Re: Stokes Estate Conditional Use  
Westtown Township, Chester County

**RE: Stokes Estate Flexible Residential Development – 927 Shiloh Road, 1007 Shiloh Road, 1011 Shiloh Road, and 1013 Shiloh Road  
Conditional Use Application**

This letter is in response to the June 17, 2023 Cedarville Engineering Group, LLC (CEG) review of the above referenced Plans by D.L. Howell and Associates, Inc.

DATE:	04/14/23
SCALE:	1"=100'
DRAWN BY:	ADM
CHECKED BY:	DWG
PROJECT NO.:	3868
CAD FILE:	01_Conservation Design_Plan.dwg
PLOTTED:	06/15/23
DRAWING NO.:	CP1.1
SHEET	1 of 2

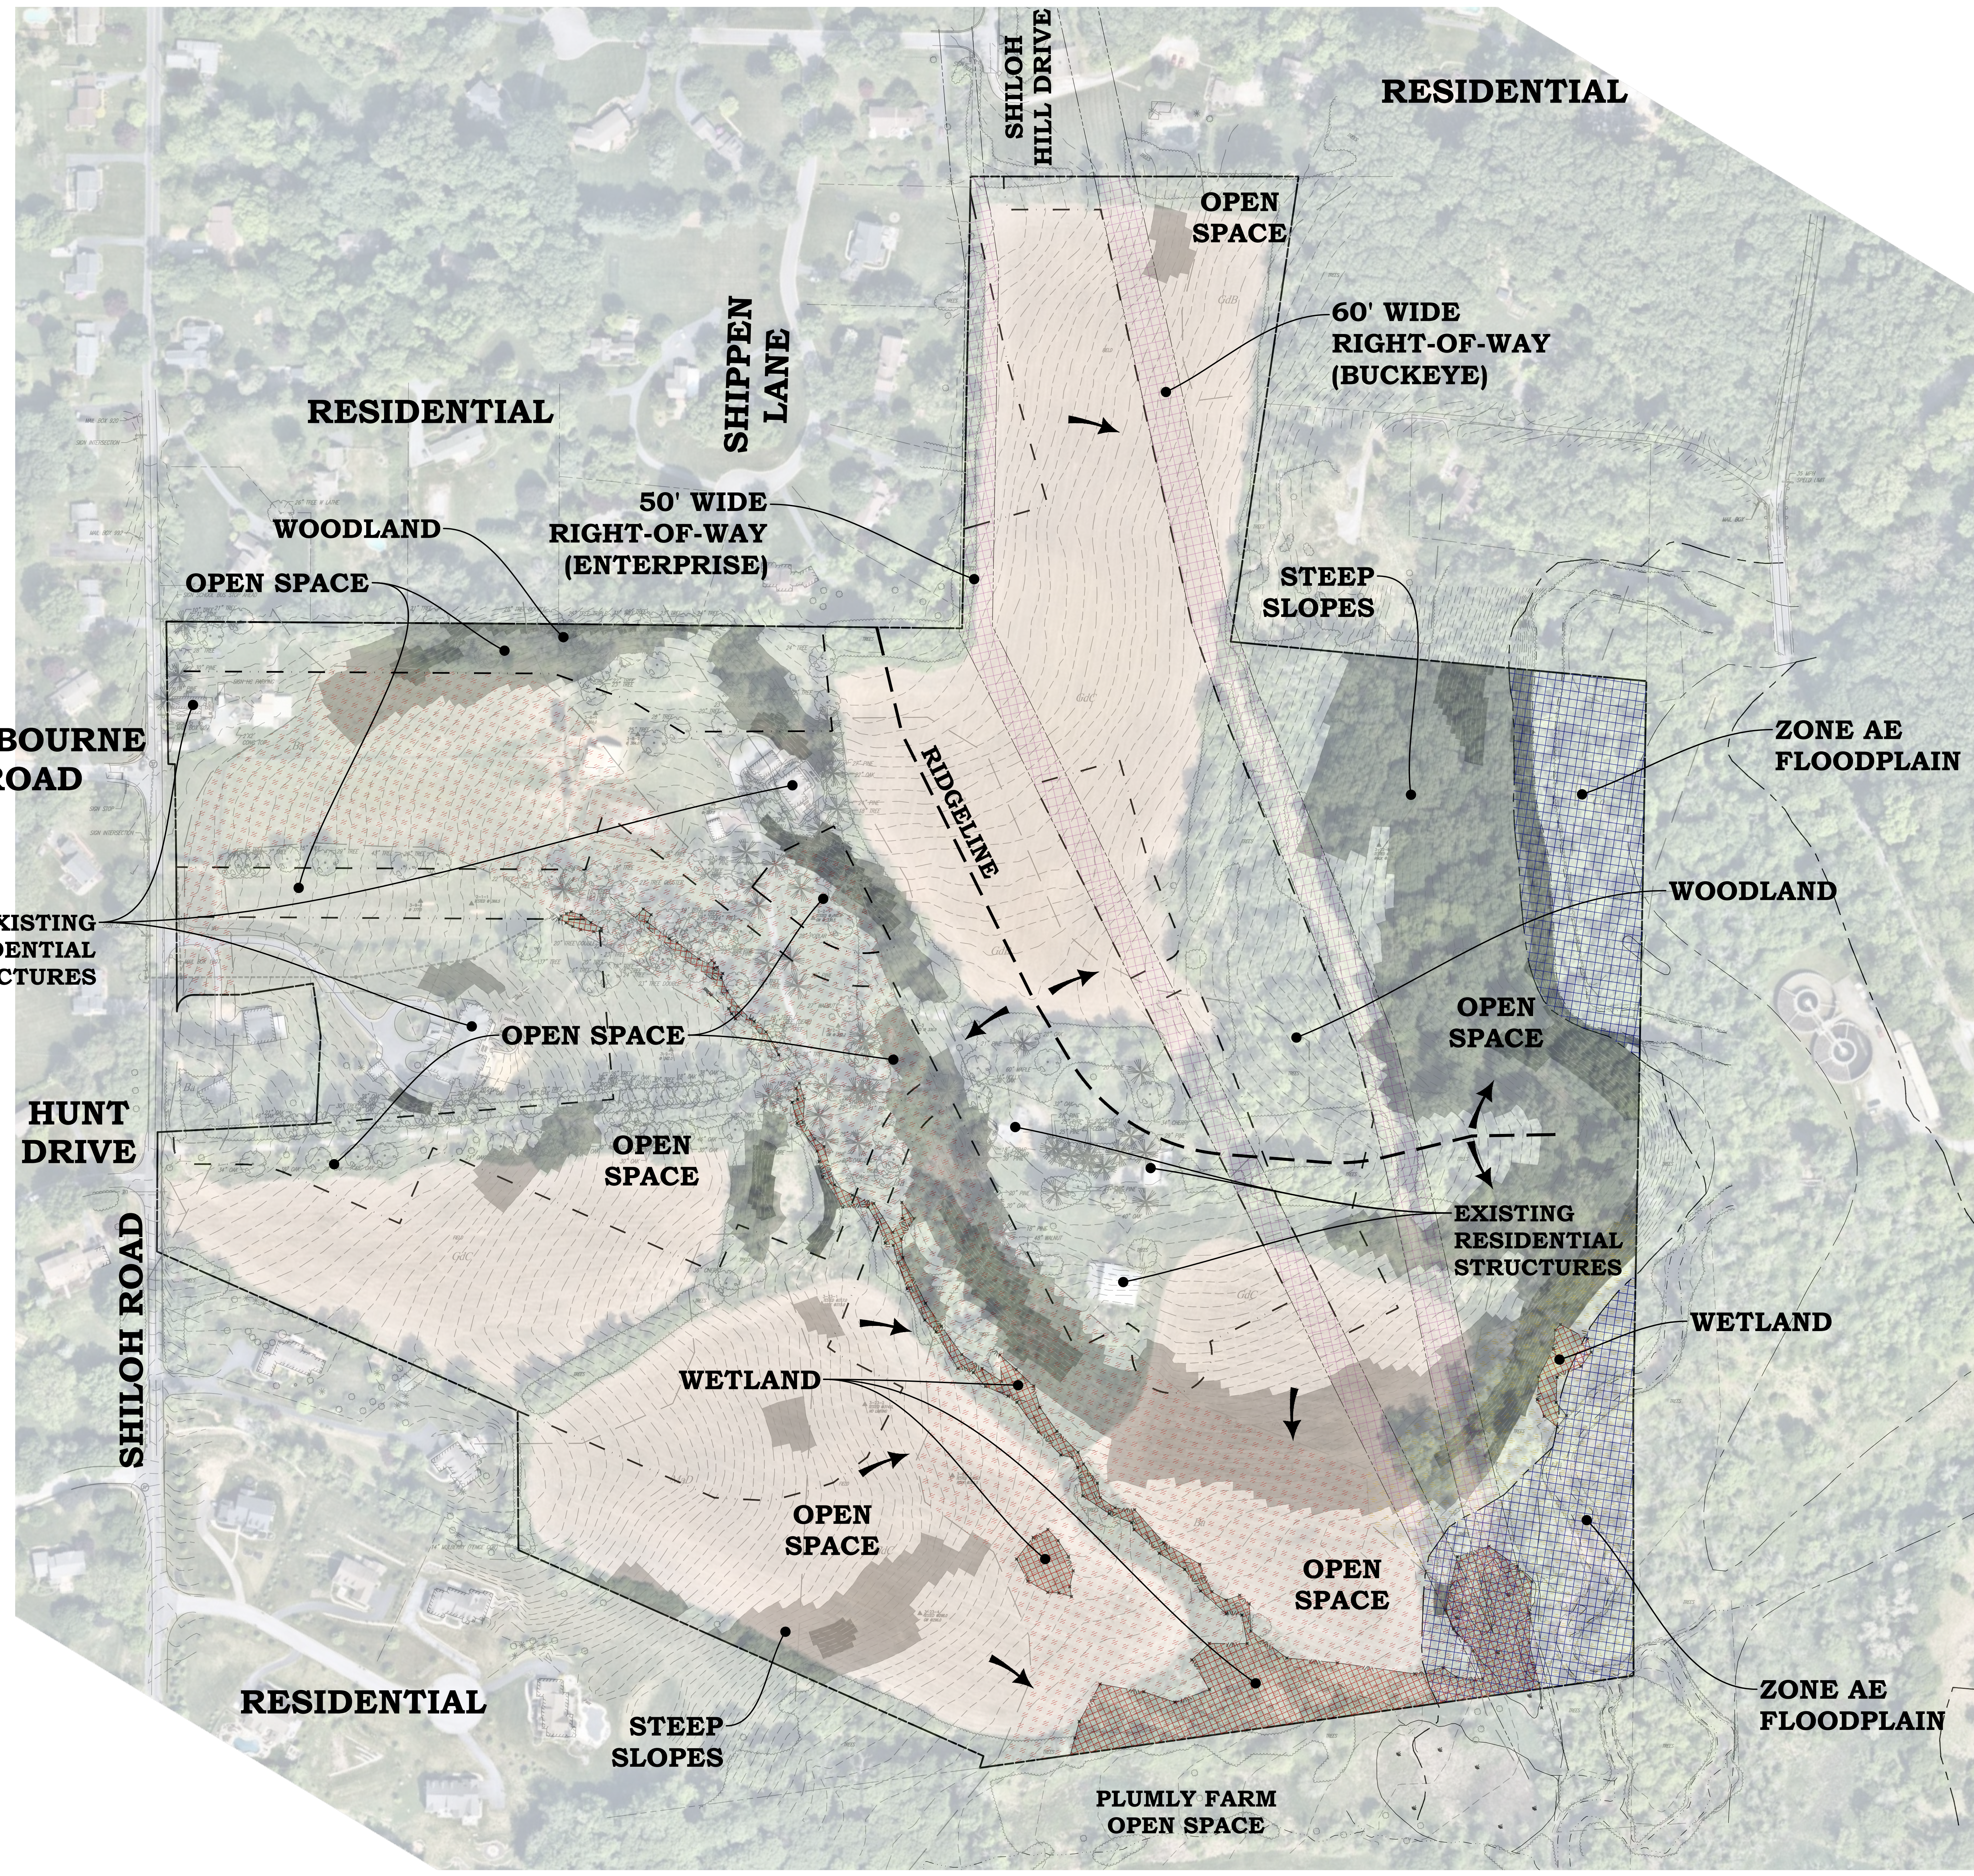
6. Conservation Design Plan does not depict clear boundaries of woodlands and tree lines, location of large specimen trees over 18 inches in trunk diameter, and scenic views from inside the site and existing streets and trails. The precise delineation of primary and secondary conservation areas is important to determine whether the application meets the requirements of §170-1617.C(2) pertaining to limitations on intrusion of land development activities and associated land disturbance into such areas. Applicant shall incorporate details of above-noted secondary conservation areas into the Conservation Design Plan map and calculations table and adjust relevant plan sheets appropriately.

9. Conservation Design Plan shall include calculations verifying that proposed land development activity and associated land disturbance is not within more than 50% of secondary conservation areas. Applicant shall provide such calculations, which will also address comment #6.

**Howell Response: All applicable secondary conservation areas including woodland lines, tree lines and specific large surveyed trees are now labeled on the Existing Resources and Site Analysis Map. As determined by the Chester County Court, the scenic views preservation requirement under the Ordinance is unenforceable. There is a calculation provided verifying less than 50% disturbance to the secondary conservation areas. Any disturbance of primary conservation areas is pursuant to permitted and development related disturbances per the Ordinance.**

**Howell Response: A full chart tabulating primary and secondary conservation areas and their associated disturbance amount is now provided on the Conservation Plan sheet 02 of 02. It confirms compliance with this section.**
